Peer Review of Flood Modelling undertaken for the Macintyre River Floodplain

Inland Rail Project
North Star to Queensland Border (NS2B)

Goondiwindi Regional Council

1283-02-D1, 27 November 2020

Figure 7-9 - Updated flood impacts for the 1% AEP design event

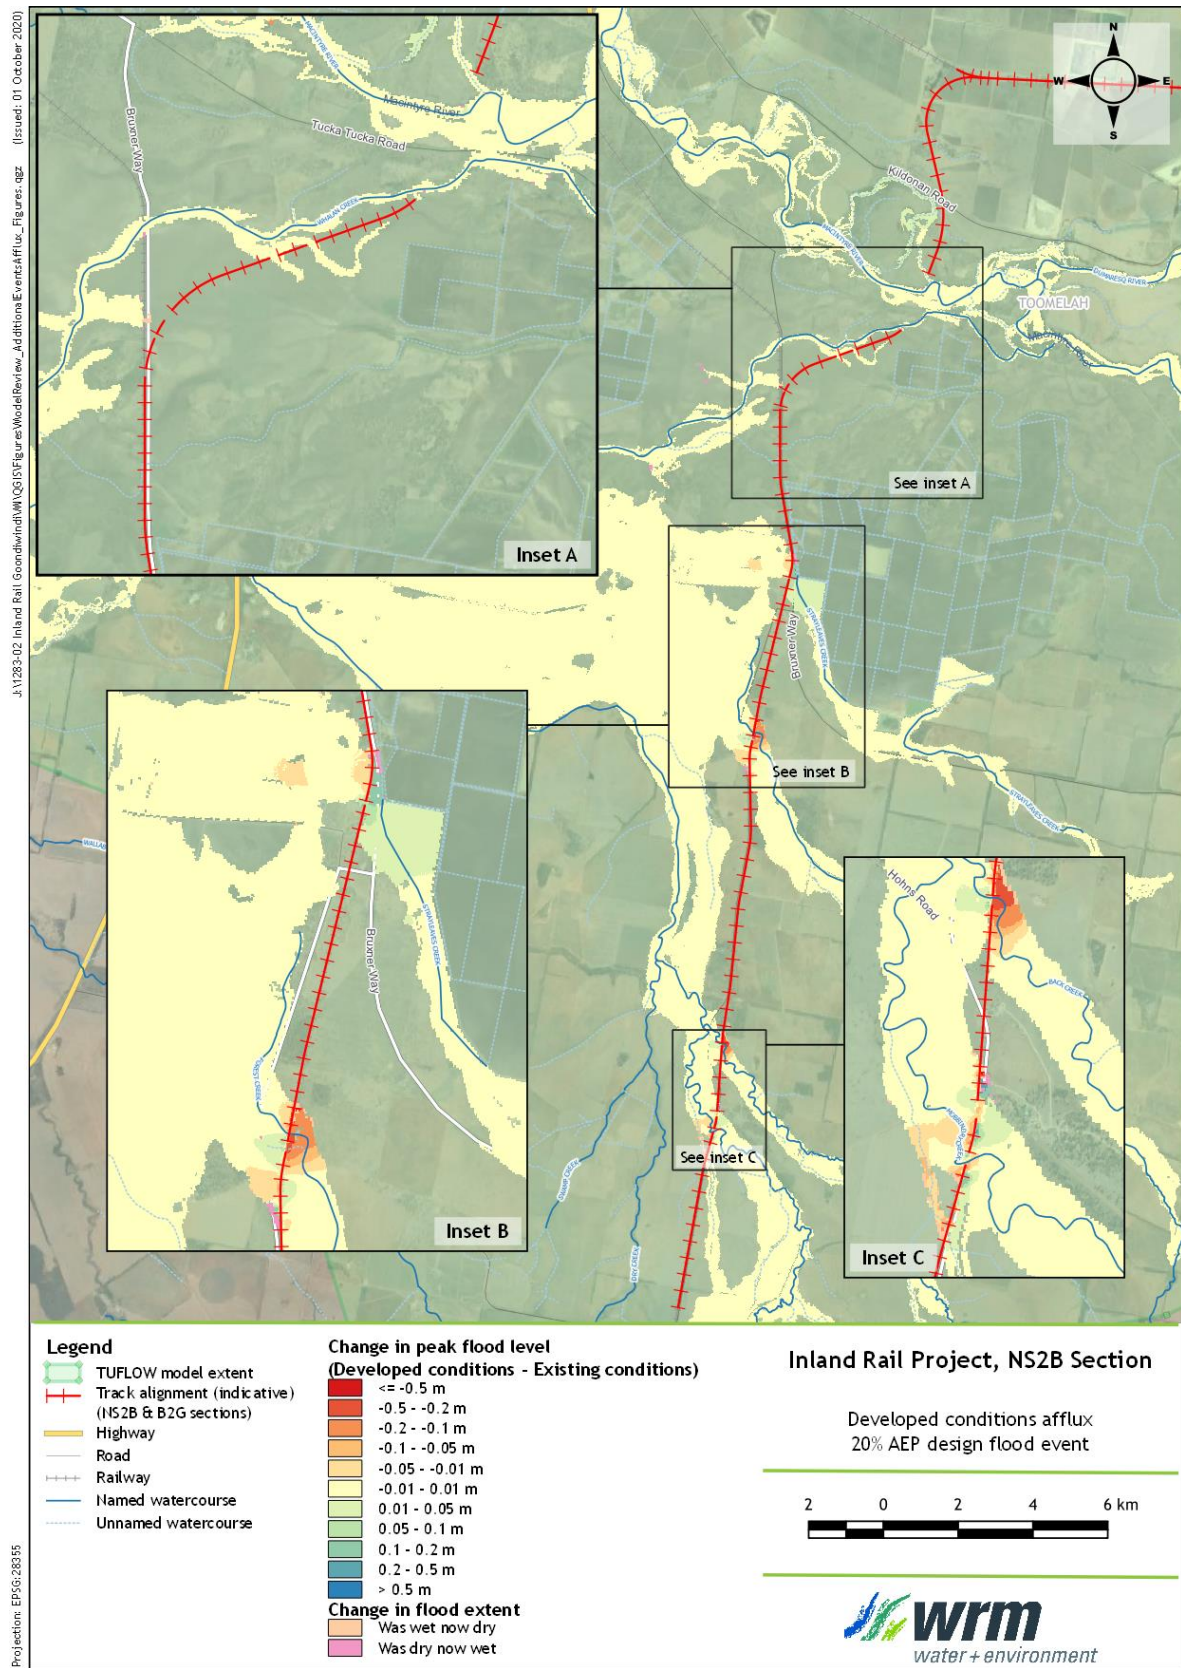
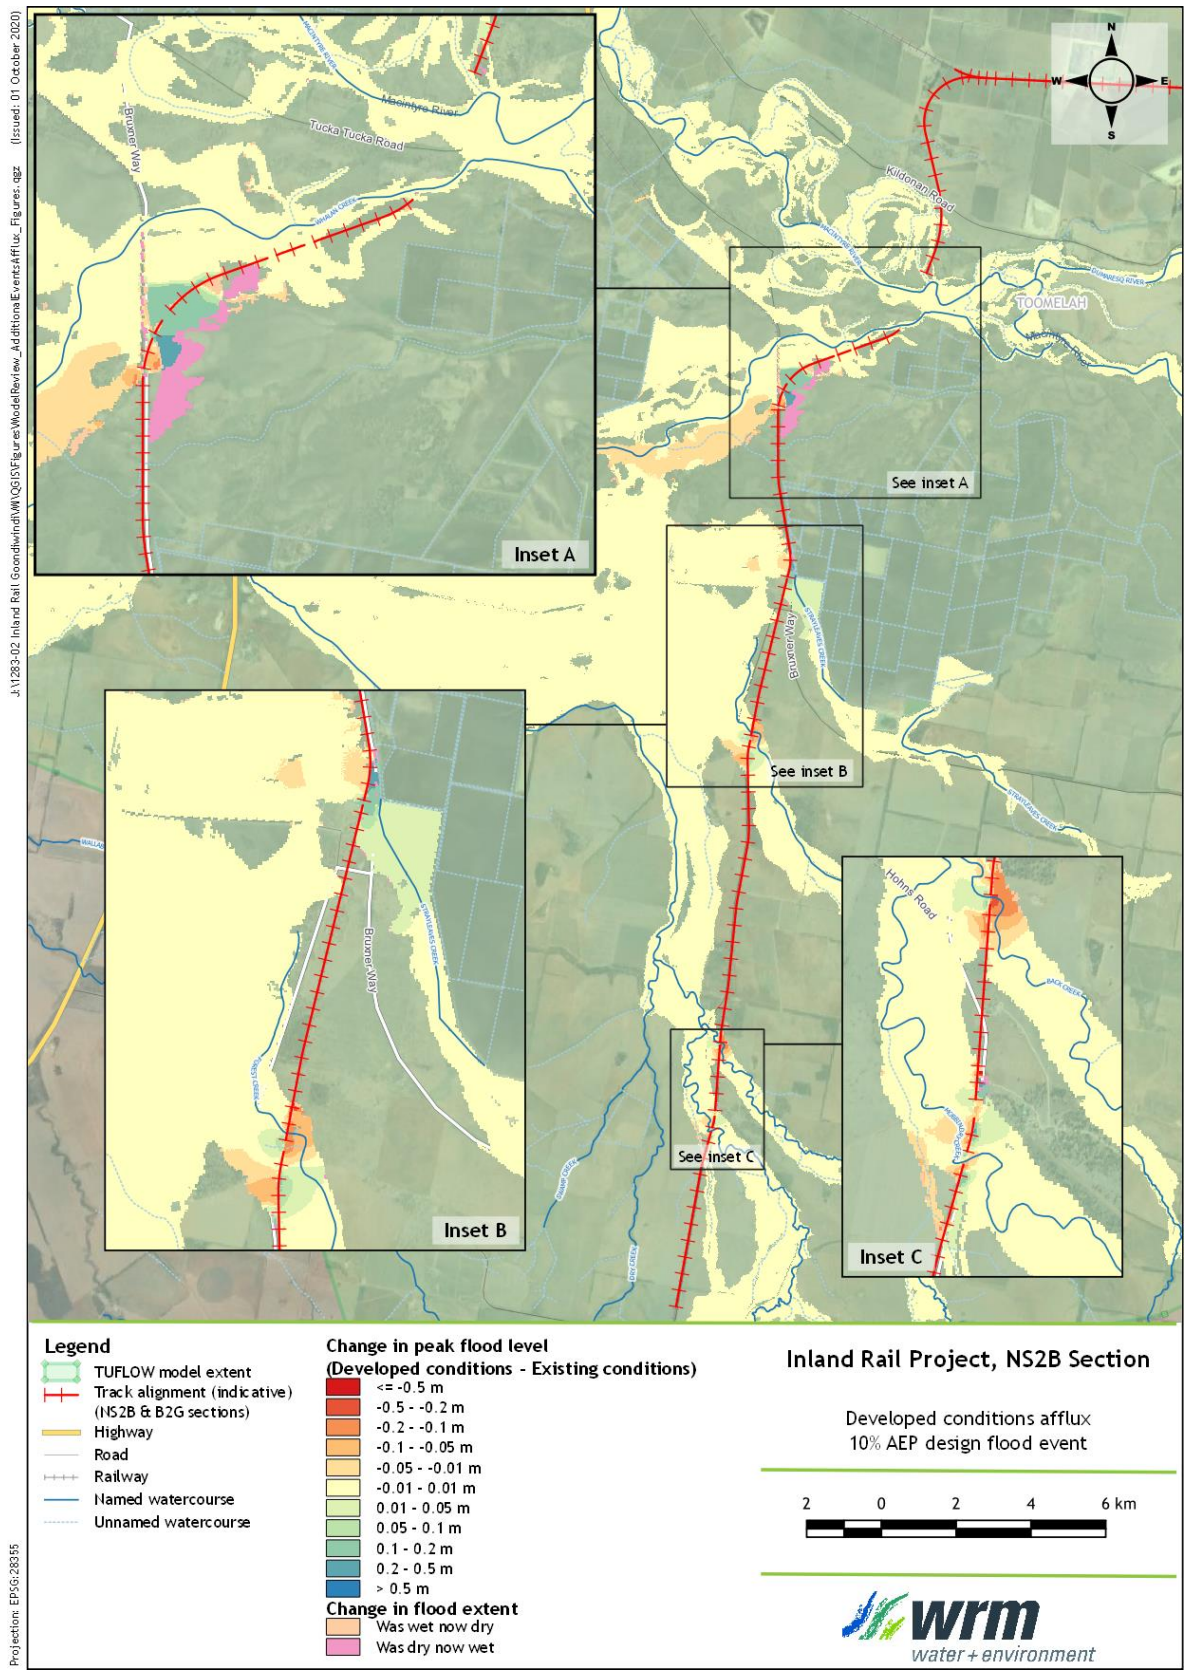
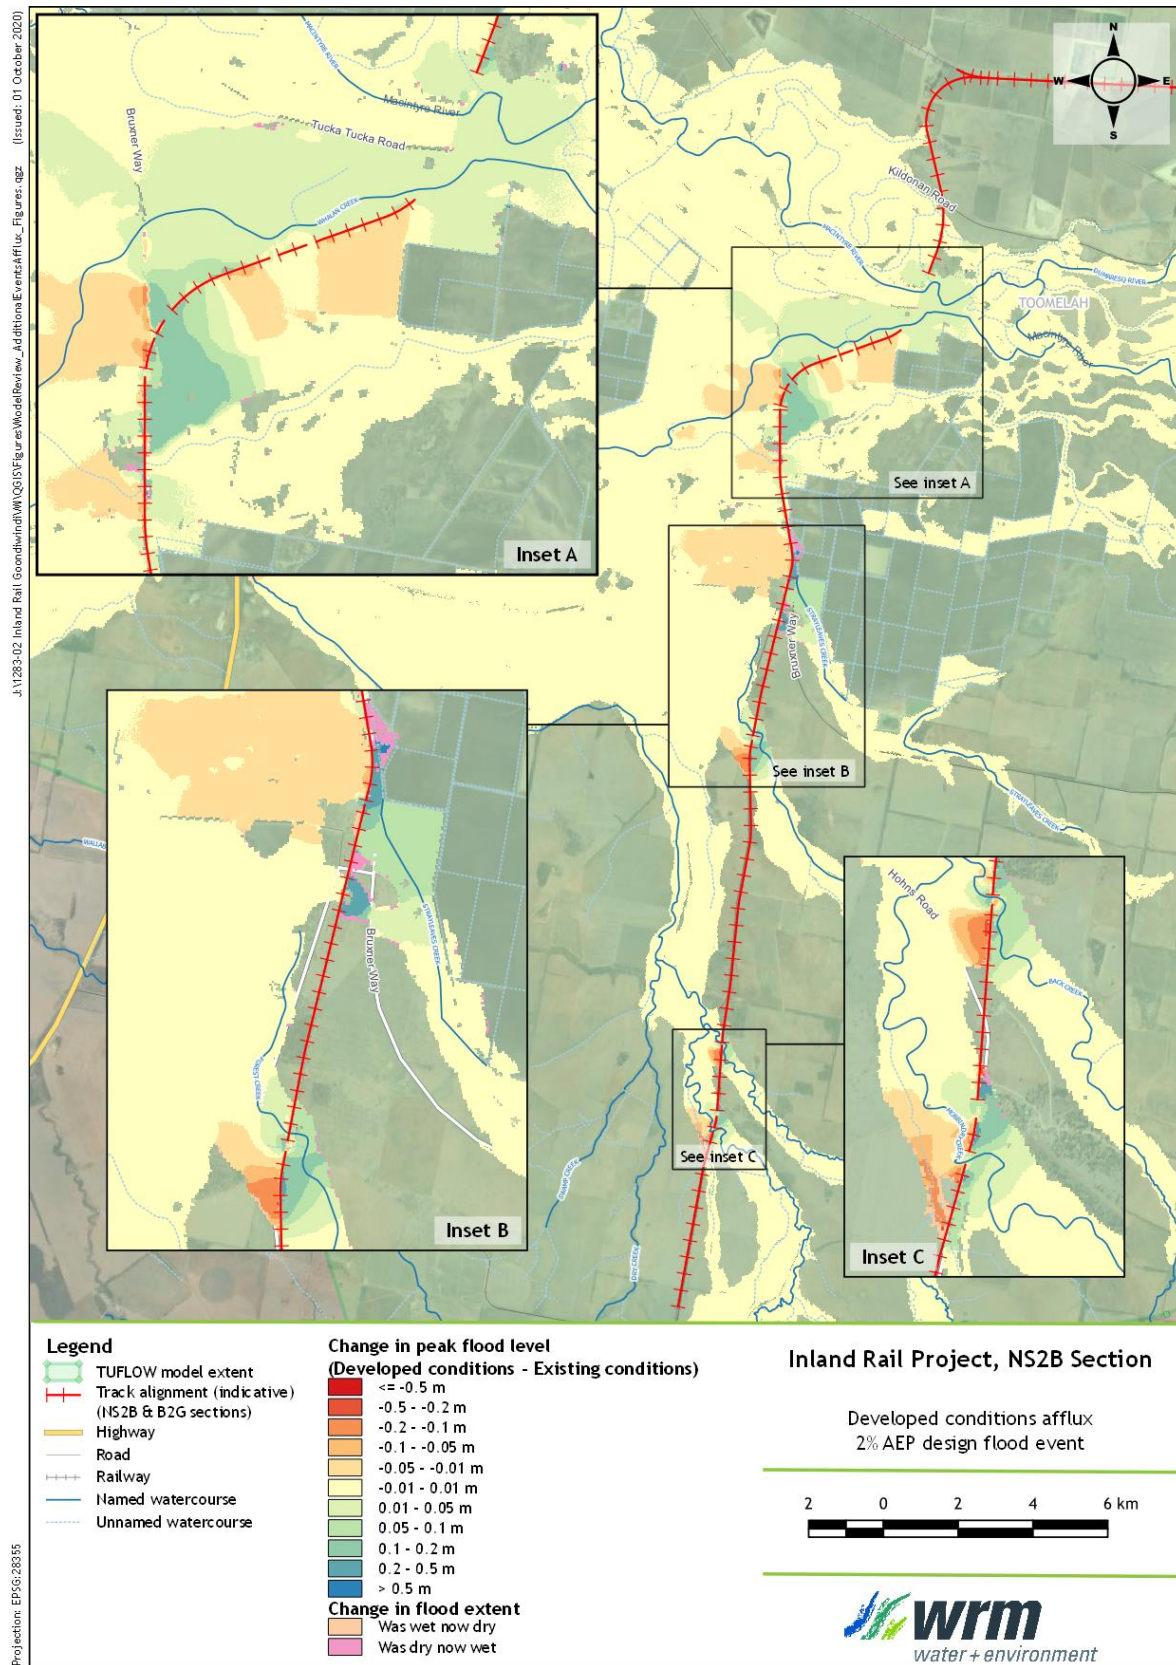
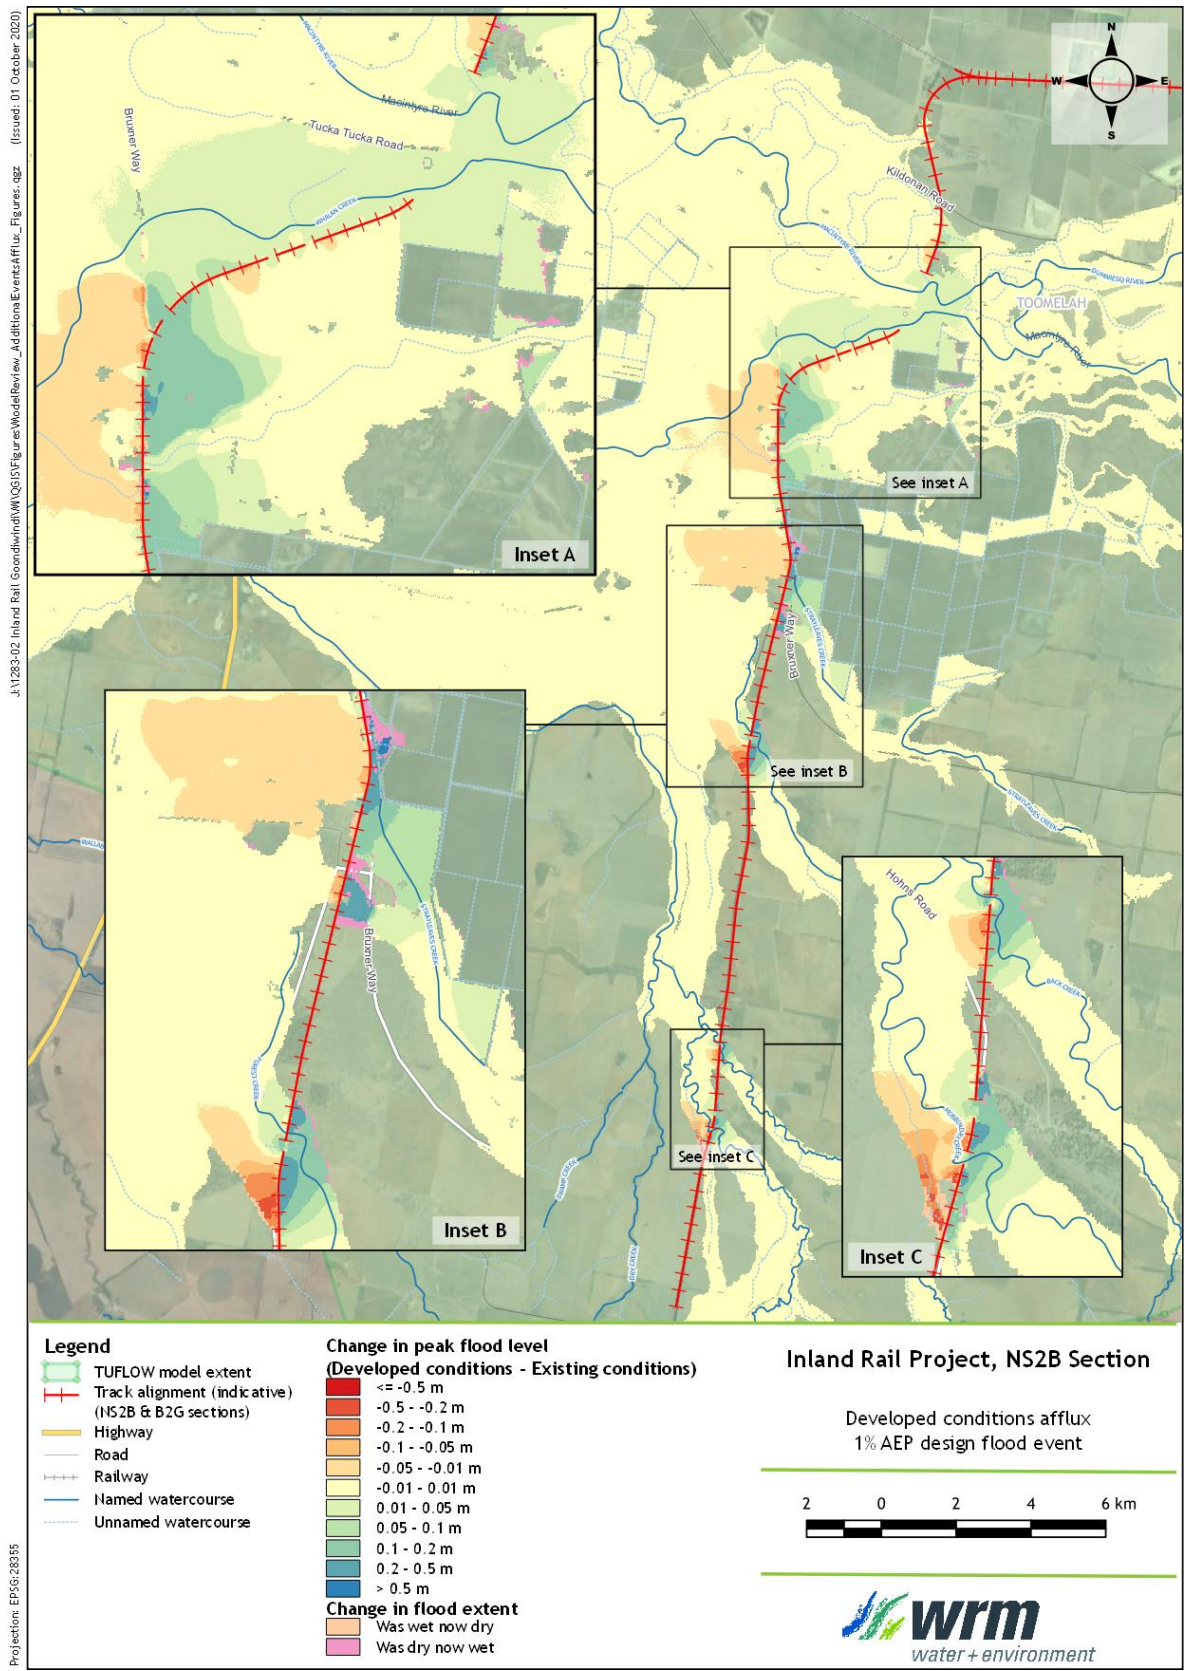
Figure 7-5 to Figure 7-9 show the updated flood impact maps for 20% AEP to 1% AEP design flood events along the NS2B alignment, including the locations where the impacts exceed the flood impact objective limits. These flood maps also show that:

- At the Mobbindry Creek crossing, there are upstream impacts that are greater than the established flood impact objective limits upstream of the rail line for all flood events shown.

- For the mapped events, the flood impacts generally increase with flood magnitude.
 - There are some localised areas with impacts greater than 0.5 m for the larger flood events.

In response to one of my queries, FFJV have acknowledged that the design flood impact maps presented in Chapter 13 and Appendix H of the NS2B EIS are not accurate, especially for the southern minor creek (Mobbindry Creek, Back Creek, Forest Creek and Strayleaves Creek) crossings of the proposed NS2B rail alignment. FFJV have indicated that they have re-checked the smaller creeks flooding for both the Macintyre River system critical storm durations and their individual critical storm durations. Upon re-checking their published mapping, they have found that the maps published in the EIS reports show the smaller creek affluxes only for the Macintyre critical duration impact, rather than the actual critical impact duration for the smaller creeks. They have undertaken to correct this error in future reporting and provided updated afflux maps for review.
